Contract Program: **Technical Support for the Reactor Systems Branch (L1697/P2)**

Subject of Document: **Review of Proposed Modifications to Emergency Procedure Guidelines for Anticipated Transients Without Scram Events**

Type of Document: **Technical Evaluation Report**

Date of Document: **November 1995**

Figure 15. Suppression pool temperature assuming level increase without boron remixing at 1300 seconds.

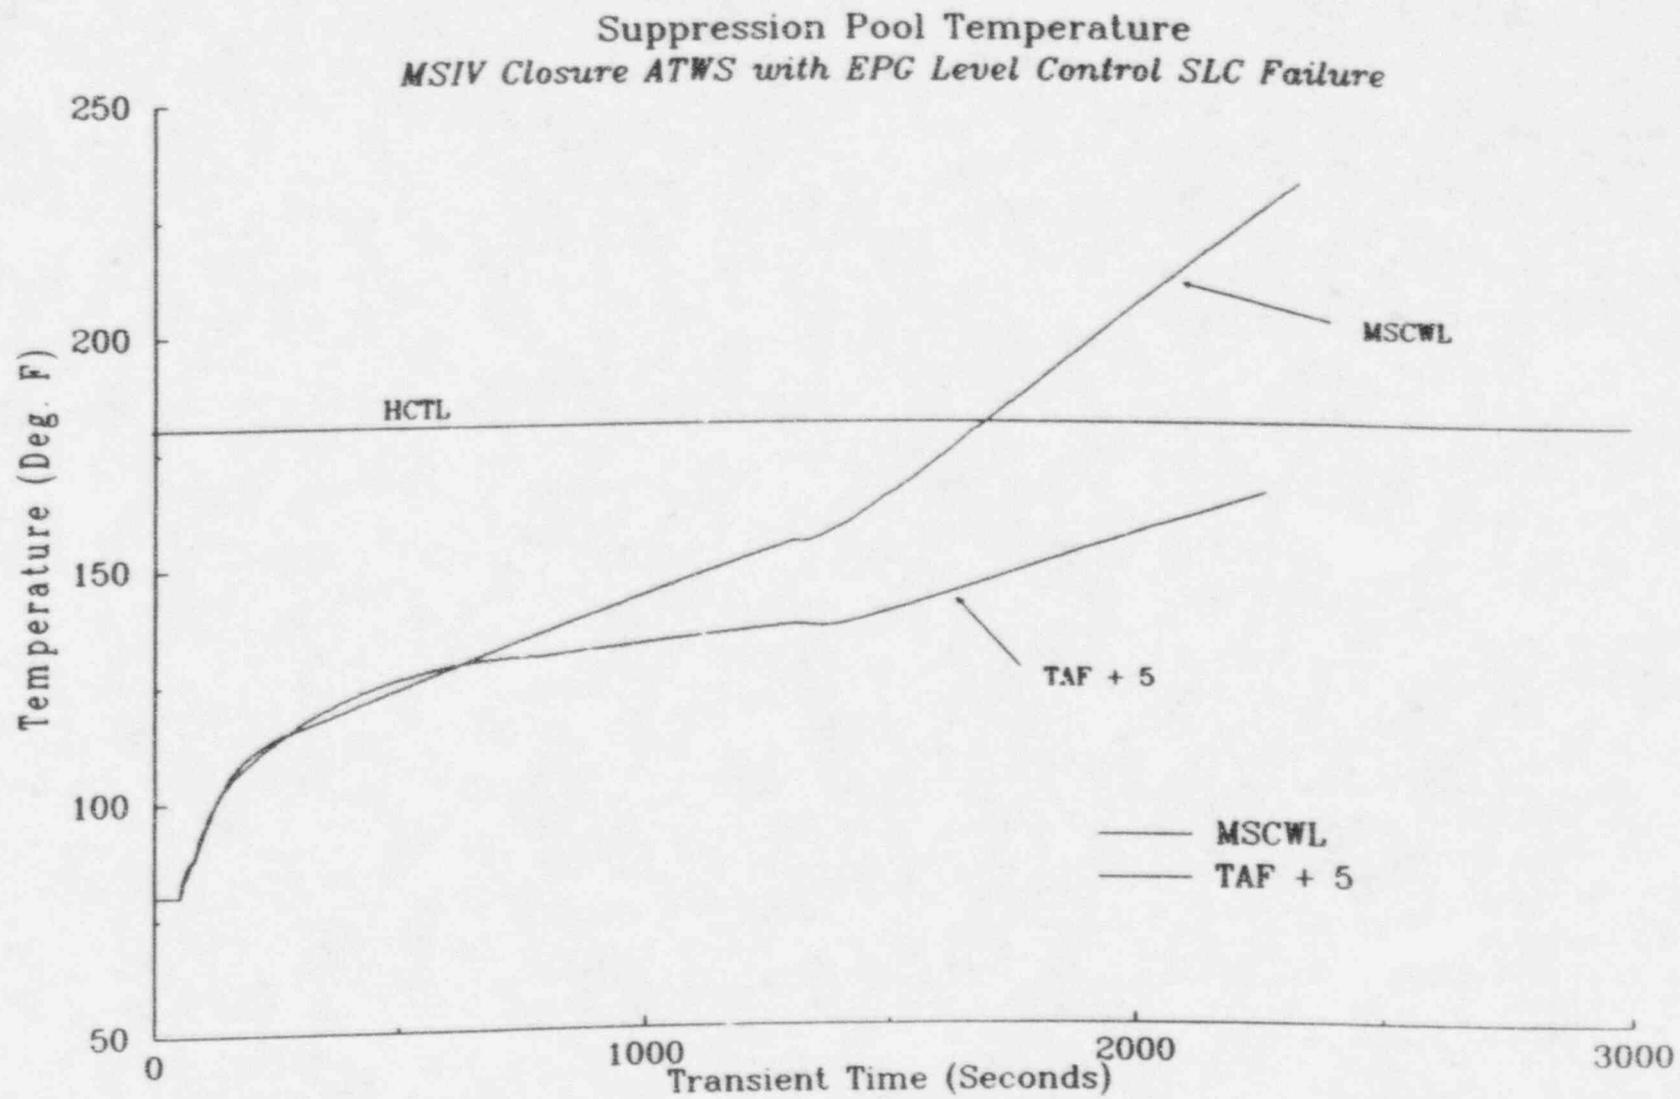
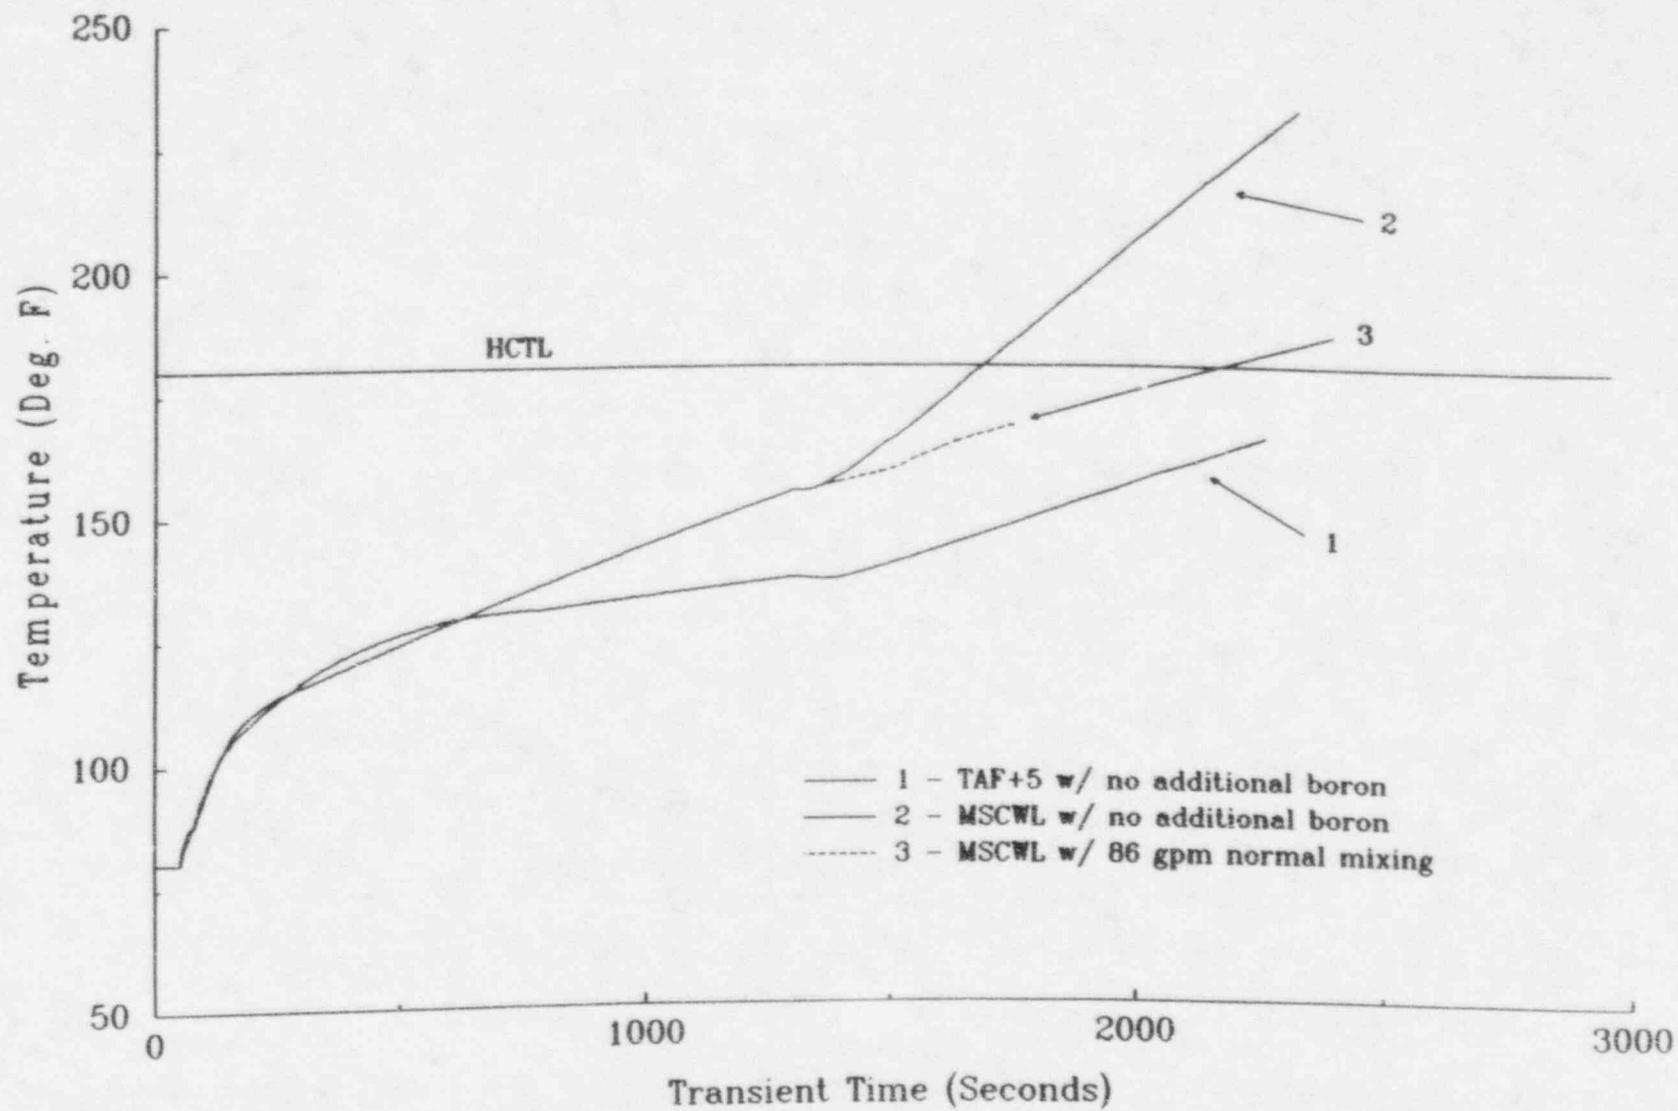
Figure 15 shows a comparison of suppression pool temperatures for the two level-control strategies when we assume that boron does not destratify and no additional boron is injected once the water level is raised. As seen in this figure, the higher-level strategy results in lower pool temperatures and more time before it reaches the HCTL (400 s for the MSCWL strategy versus 1400 s for the TAF + 5' strategy).

The calculations in Fig. 15 are extremely conservative; they not only assume that boron does not destratify, but also assume that no additional boron is injected once the level is raised. Figure 16 shows a slightly less conservative calculation, where the stratified boron is assumed not to remix, but we take credit for the additional boron that is injected by the SLC system after the level is raised and the flow increases back to 20%. When this additional boron injection is accounted for, the time available before HCTL is reached is increased significantly, and it provides more than the 10 minutes that may be required to remix the stratified boron.
